S.I. Number: M20-35

SERVICE INSTRUCTION

Inspection of Empennage Attach Brackets

MODELS AFFECTED: All M20 Series aircraft equipped with metal tails

FIGURE 1

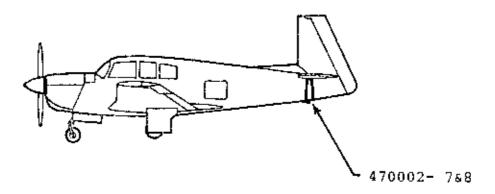
- 1) Remove 470002-7 and -8 fairings (Figure 1).
- Check torque on the AN 174-20A bolt (Figure 2) 2) 60-70 IN-LBS. dry threads. (Due to the inaccessibility of the nut the torque must be checked on the bolt and consideration must be given to friction in accordance with AC 43-13 Chapter 5, Section 227.)

- Install 470002-7 and -8 fairings (Figure 1). 7)

FIGURE 2 (View Looking Up)

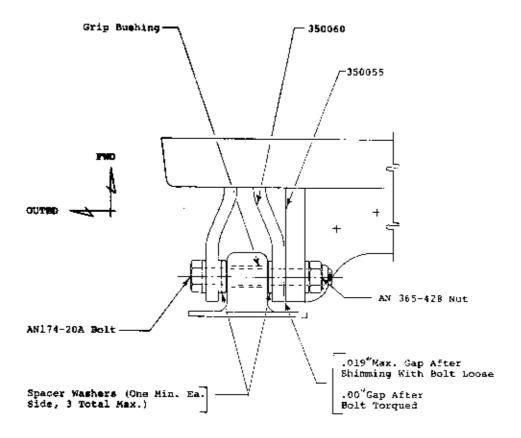
Evidence has been found that an accumulation of assembly tolerances may result in decreased rigidity of the empennage at the attachment to the tailcone. Since this condition is likely to exist in all M20 Series airplanes equipped with all metal tails it is necessary that the following inspection and corrective action be performed.

- 3) Using a .005 feeler gage check between the 350060 bracket and the 350055 fitting (Figure 2). feeler gage touches shank of bolt continue with If gap does not exist no rework is Step 4. required.

- 4) Support the empennage and remove the bolt carefully noting the arrangement of washers used as spacers. These must be replaced in the reverse order of removal.

- Shim as required to eliminate gap between the 5) 350060 bracket and the 350055 fitting with aluminum shim stock in the shape of an AN 960-416 washer. "Do not use brass shim stock". (Maximum allowable gap with bolts loose and shims installed is .019").

- Carefully inspect the condition of the AN 174-20A bolt. Replace if any signs of wear are evident. Reinstall the AN 174-20A bolt, washers, and AN 365-428 nut in the reverse order of disassem-Torque to 60-70 IN-LBS. (dry thread) and again check gap between the 350055 fitting and the 350060 bracket.
